## TECHNICAL MEMORANDUM

**Date:** March 15, 2019  
**To:** Christine McLean c/o Matthew Nefstead  
**From:** Rina Freed, PhD., P.Eng.  
**Subject:** SEA Review of Mount Polley Monitoring Data – EMA Permit 11678

Figure 13: Observed (box plots) and Predicted (lines) Concentration of Copper

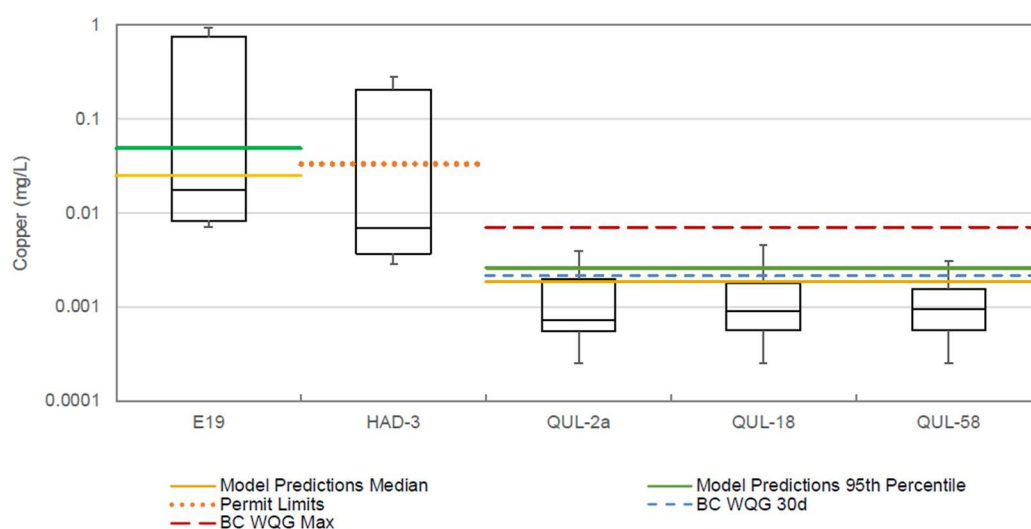
SEA is concerned that permit limits have been exceeded for T-Cu, D-Al, D-Cd and water quality guidelines were not met at the true 100 m IDZ (at the centreline of the plume). Measured data were higher than predictions due to high background concentrations. This means the receiving environment is sensitive to these parameters (and appropriate water treatment should be employed).

Figure 13 shows the total copper exceedance of model predictions prior to “treatment” at E19; exceedance of the permit limit at the effluent (HAD-3); and the exceedance of the BC WQG (30 d) in the receiving environment. The water quality guidelines do not “continue to be met in the lake” as shown in Figure 13. While the exceedance of the BC WQG for copper above (chronic) may be related to background, it is not clear what change the effluent is having on the 100 m IDZ maximum plume value. SEA expects that given the two orders of magnitude difference in the discharge effluent and the receiving environment, a change in water quality at the 100 m IDZ is to be expected. Very little dilution is expected to be available when the background

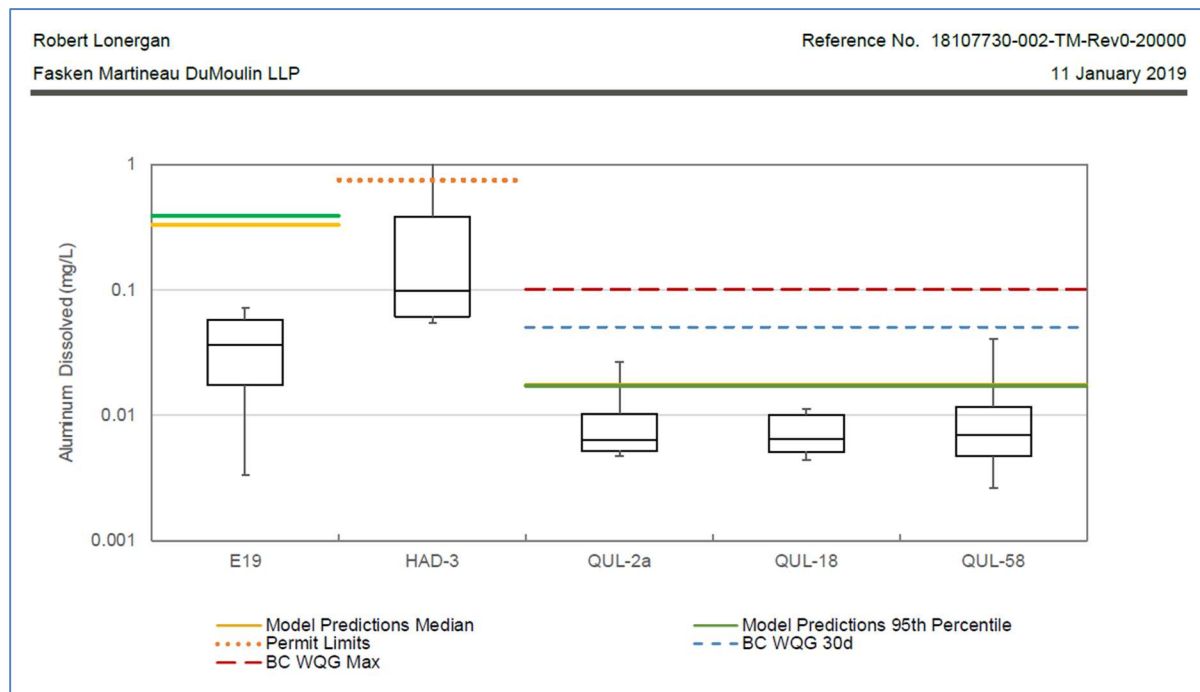
Given the problems with the plume centerline identification, the minimum dilution factors determined should not be disregarded as they are closer to the true dilution factor than samples taken farther from the plume centerline. SEA notes that very low values were

measured at times (dilution factor less than 10, Attachment 2, Table 1). While there was no discharge at this time, the values are still important as other times of the years there could be a similar (or lower) amount of dilution (i.e. winter). It appears that the minimum values were not treated appropriately. This may show a bias to disregard important data for invalid reasons.
